ISSUE: Permit to Demolish/Capsulate (partial) and Certificate of Appropriateness for alterations and addition

APPLICANT: Hershel Kleinberg and Lisa Cohen

LOCATION: Old and Historic Alexandria District
329 North Washington Street

UPDATE

Figure 3: existing south elevation on left; proposed on right.

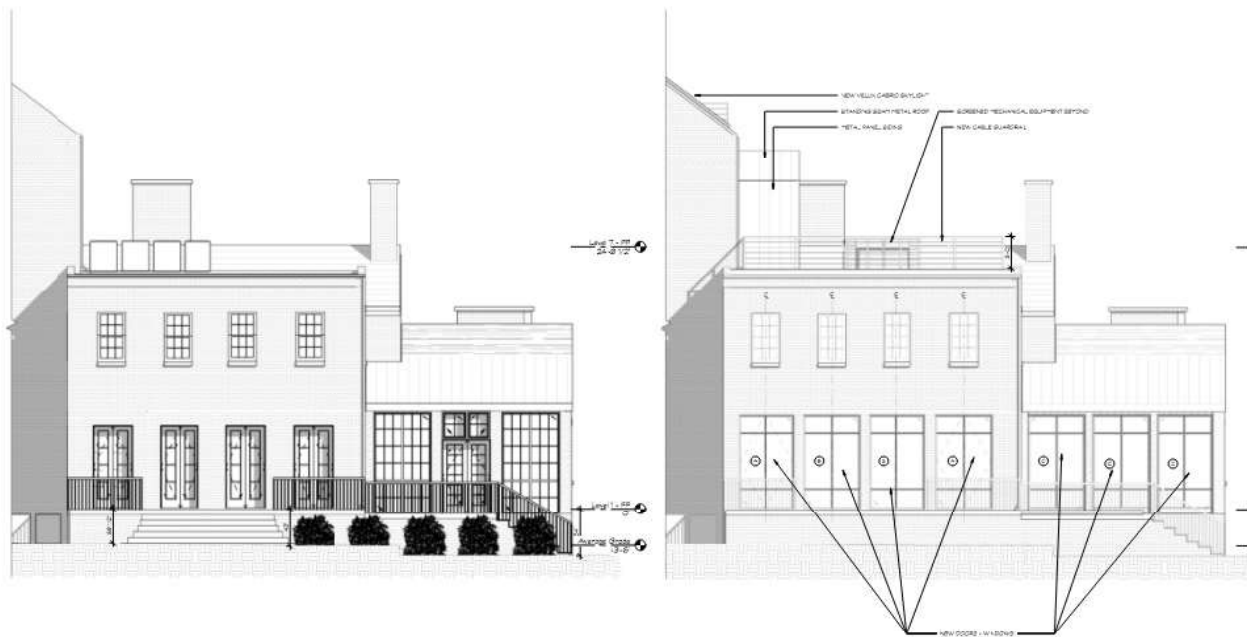
In addition to replacing all windows and doors on the first floor of the south elevation, the applicant proposes to replace a basement access door on the east elevation that was added in 2001. None of these changes are visible from a public right of way. Additionally, existing rooftop HVAC units (see Figure 3) will be relocated to the north side of the roof deck and screened. At ground level, in the yard on the south side of the main block of the house, a third HVAC unit will be added to two existing units in this location. These are not visible from North Washington Street.

Staff recommends approval of the project as submitted, preferring the terra cotta metal siding for the elevator. Staff also endorses the recommendations of Alexandria Archaeology.

sheet title:
Existing vs.
Proposed -
East

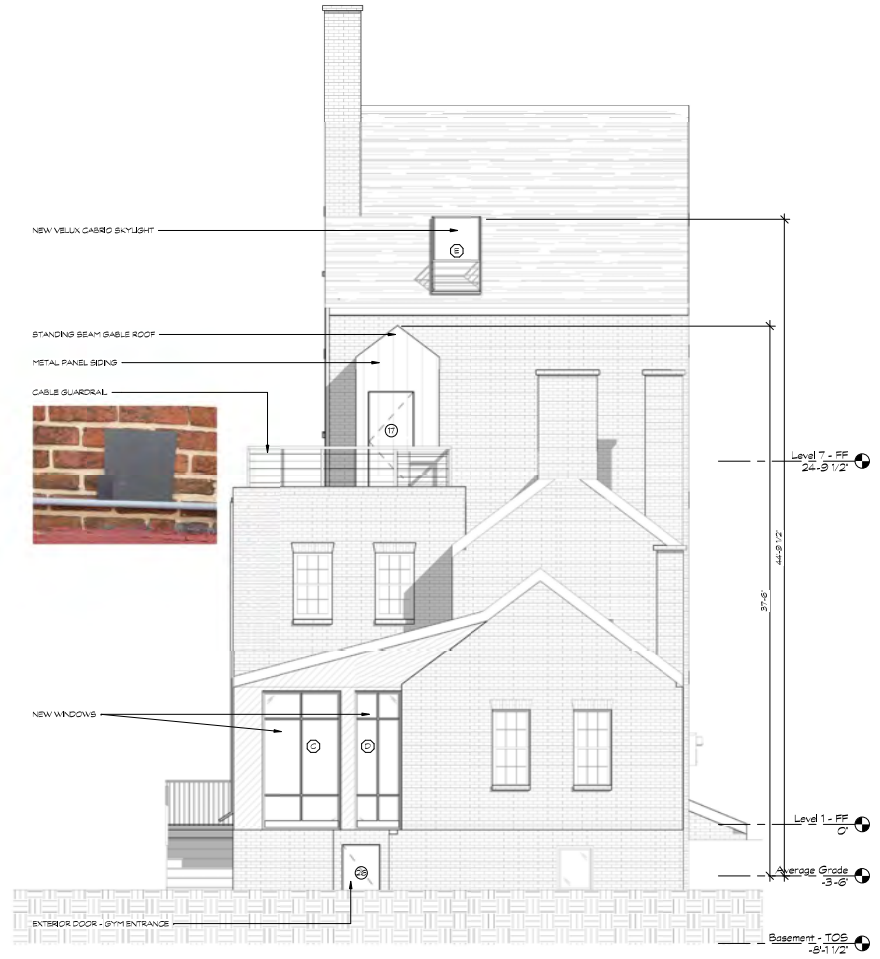
The Board was concerned that the color of the elevator enclosure could make it too visible and that the proposed 8” gap between the elevator and the exterior wall would create future maintenance issues. Also, the submitted elevation from Princess Street did not accurately depict the grade.

Ms. Sennott asked if the proposed elevator would touch the wall. Ms. King explained that the applicants wanted to minimize touching the building and therefore set the elevator 8" back from the exterior wall. Mr. Spencer and Ms. Irwin indicated that this would create future maintenance and waterproofing issues.

Ms. Irwin discussed potential maintenance problems with an 8" gap and recommended that the elevator enclosure abut the building with waterproofing and flashing. Mr. Spencer echoed Ms. Irwin's comments.

As recommended by the Board at the prior hearing, the applicant has altered the original design of the proposed elevator. Instead of providing an 8” gap between the elevator and the historic building, which would cause future maintenance issues, the elevator will now abut the building with weatherproofing and flashing protecting the connection. The applicant has also provided color samples for the metal panel siding that will clad the elevator. Of the three colors, staff recommends the terra cotta, which will best camouflage the elevator.

□ Color Options:

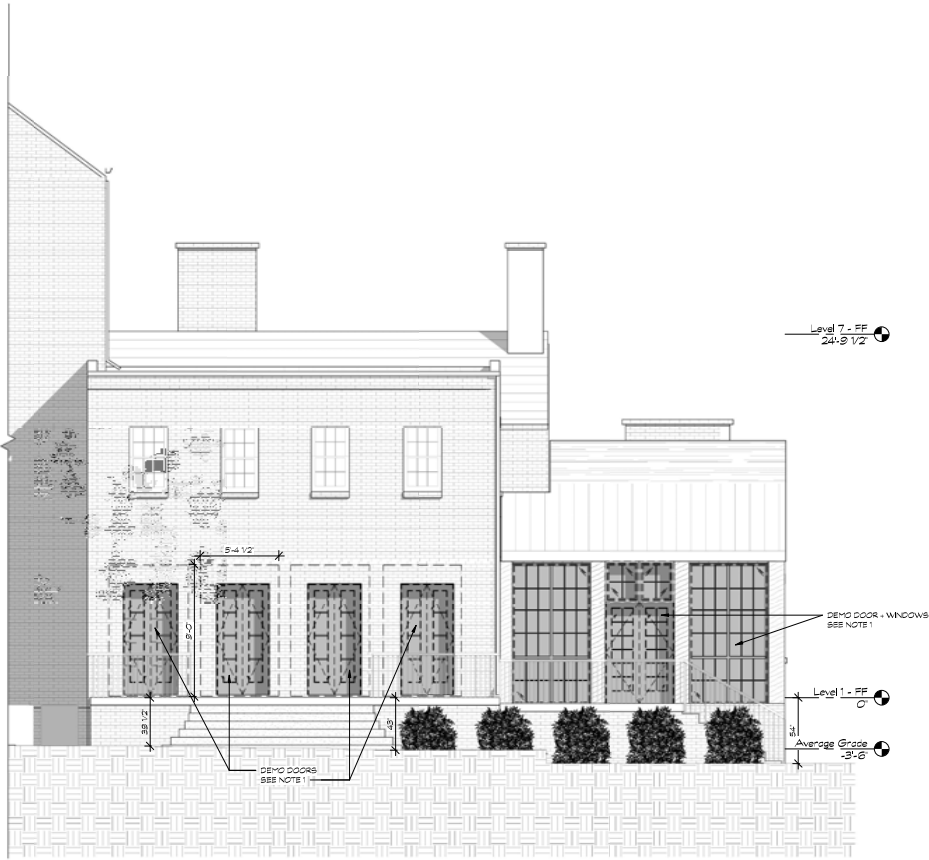
Applicant return with images of color of elevator siding as compared to the brick, changes to the connection between the elevator and the building, and updated elevations accurately depicting the grade.

Mr. Spencer asked about the color of the metal siding proposed for the elevator. Ms. King said that they intend to use a dark shade to match the building trim and roof.

Ms. Roberts suggested that the applicant return with a materials board, but Ms. Irwin said that photographs of proposed materials' colors alongside the existing brick would be preferable. Ms. Roberts would also like to see more details on the cable railings.

4. Applicant use terra cotta color metal siding for the proposed elevator.
